**CITY OF CITRUS HEIGHTS
PLANNING DIVISION STAFF REPORT
PLANNING COMMISSION MEETING**

January 24, 2018

REQUEST

The applicant is requesting approval of a Minor Use Permit, Design Review Permit and Tree Permit that will allow for the development of a 42-unit apartment project. The applicant is also requesting adoption of a Mitigated Negative Declaration.

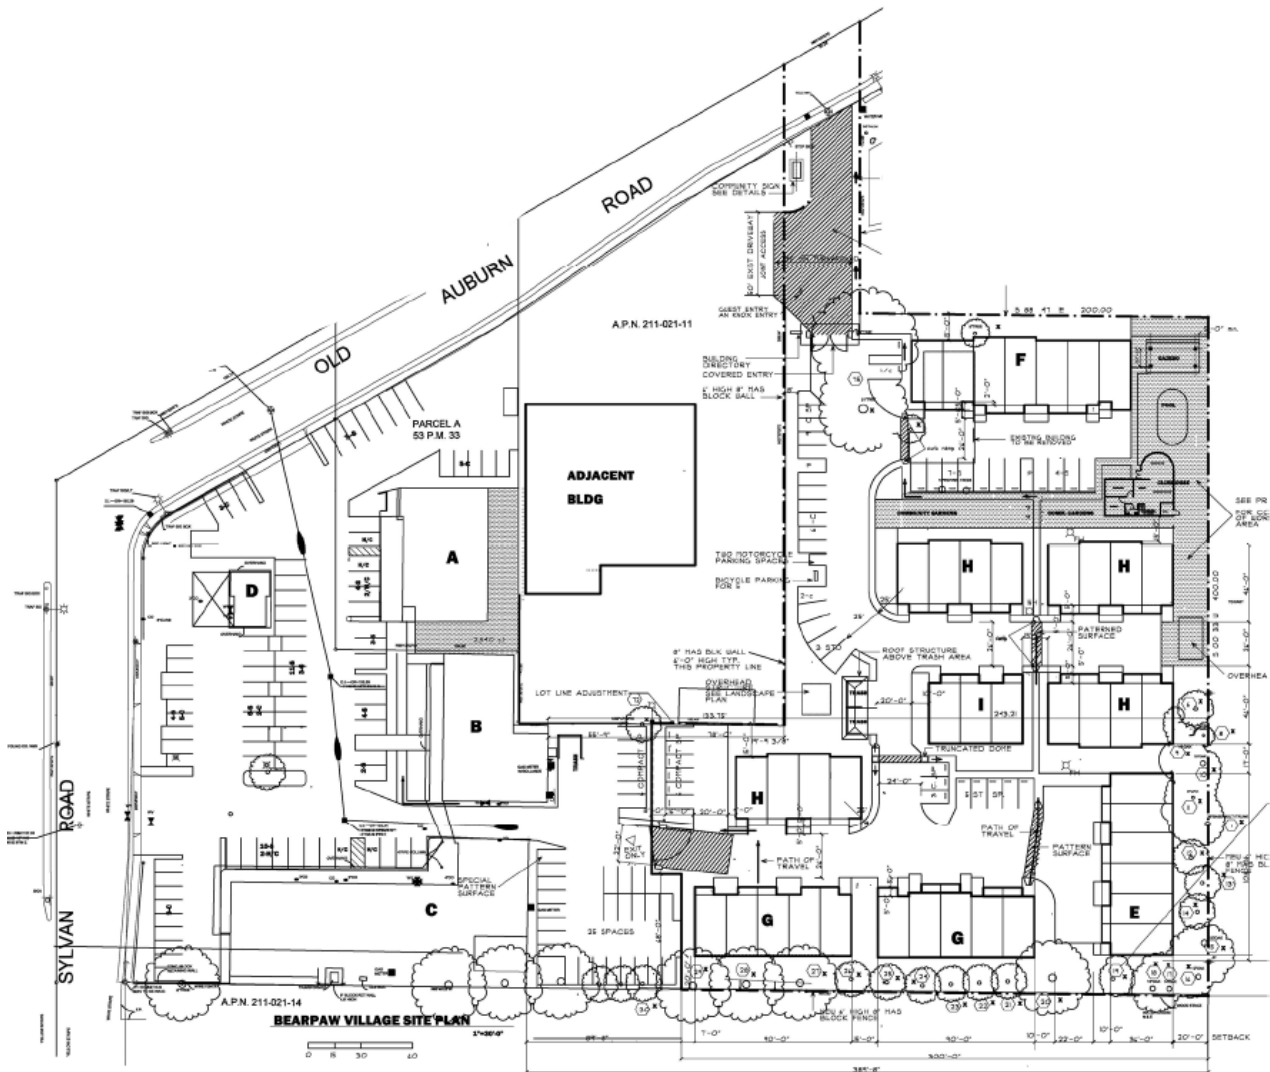
The applicant is proposing to construct 10 buildings on the site. A breakdown of the buildings proposed for the site is provided below:

Building E (6 units)	-	1 building
Building F (7 units)	-	1 building
Building G (5 units)	-	2 buildings
Building H (4 units)	-	4 buildings
Building I (3 units)	-	1 building
Clubhouse/office	-	1 building

A pool and 2,270 square foot clubhouse is located in the northeast corner of the project. Within this community area are gazebos, BBQs and similar amenities. A unique feature, located just west of the clubhouse, is a community garden. As shown on the preliminary Landscape Plan (Exhibit C), the community garden consists of 20 individual raised planters ("horse troughs") where residents can plant their own gardens.
